The New York State Department of Environmental Conservation (NYSDEC) has reviewed the plan "Culvert Addendum", dated November 17, 2025, for the Van Buren Town Landfill (site), which was prepared by Hunt Engineers. The NYSDEC hereby approves the request for the addition of a culvert as is set forth in the attached plan.

Subject: Van Buren - Detail ballast culverts

Re: Culvert Addition to Ensure Adequate Drainage
TJA-NY-Van Buren Solar-Dump Road & Kingdom Road, Baldwinsville, NY 13027
HUNT #: 3615-004

1 BALLAST CULVERT CROSS SECTION DETAIL
SCALE: N.T.S.

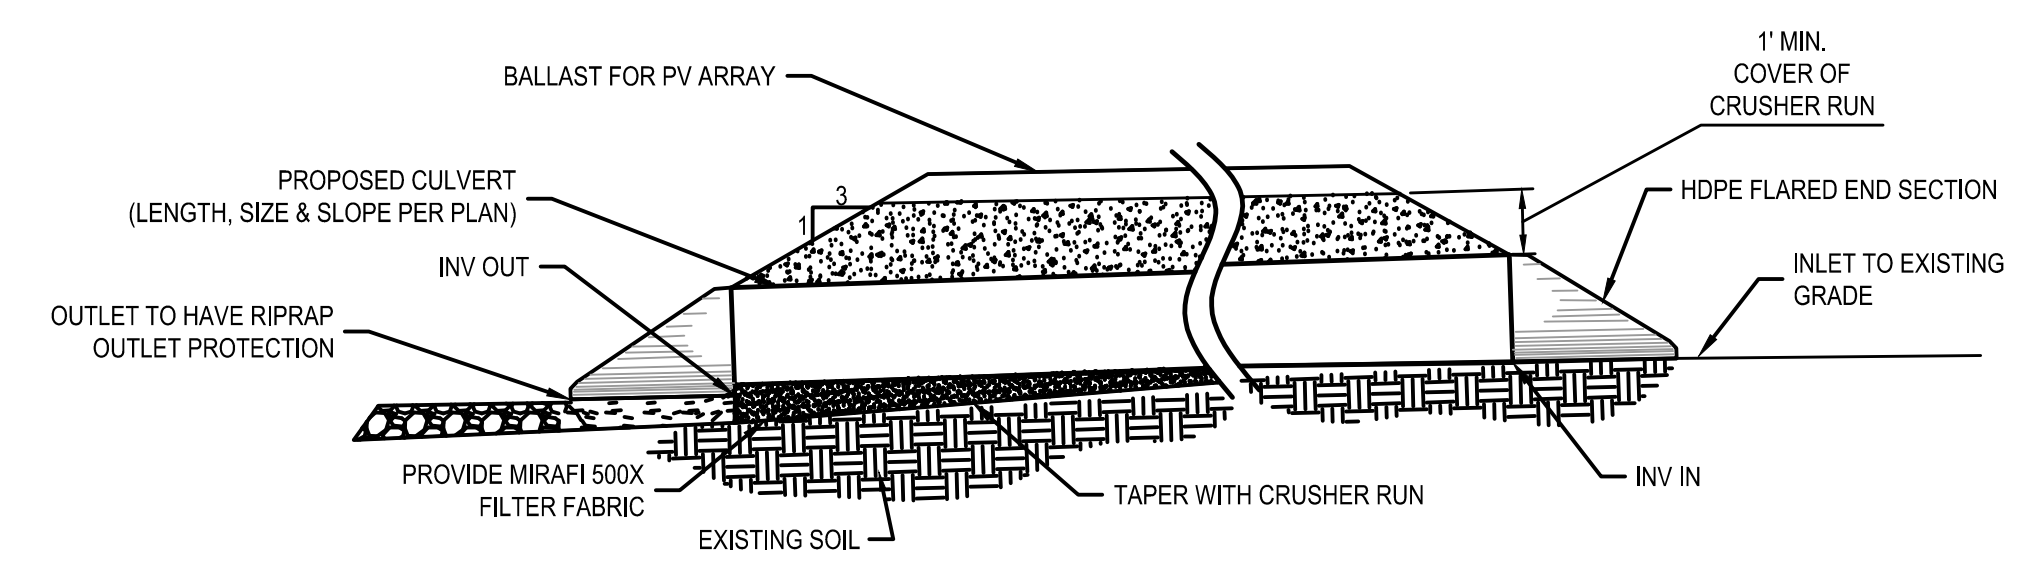
Thank you for this summary. I have one additional question. Can you clarify how the culvert will be anchored in place?

1. Please provide a written summary for why this change needs to be made along with a written description of the work that is to be done.
2. Does this culvert plan require ground intrusive work on the landfill cap? Will this plan increase the load on the landfill cap and by how much?
3. Has there been any change in the ballasts from the approved work plan? It is my understanding that the exact locations may have changed along with a decrease in the exact number. Is this correct? Are there any other changes that were made?

The culverts will be covered in crushed stone.

1. Please provide a written summary for why this change needs to be made along with a written description of the work that is to be done. - **We plan to supply this letter asap. It is in finals stages of internal review.**
2. Does this culvert plan require ground intrusive work on the landfill cap? Will this plan increase the load on the landfill cap and by how much? - **No ground intrusive work is allowed or required**
3. Has there been any change in the ballasts from the approved work plan? - **Yes, adjustments were made for final design.**
4. It is my understanding that the exact locations may have changed along with a decrease in the exact number. Is this correct? - **There was a decrease in the number of modules, and they were maintained away from the steeper edges of the cap.**
5. Are there any other changes that were made? - **no**
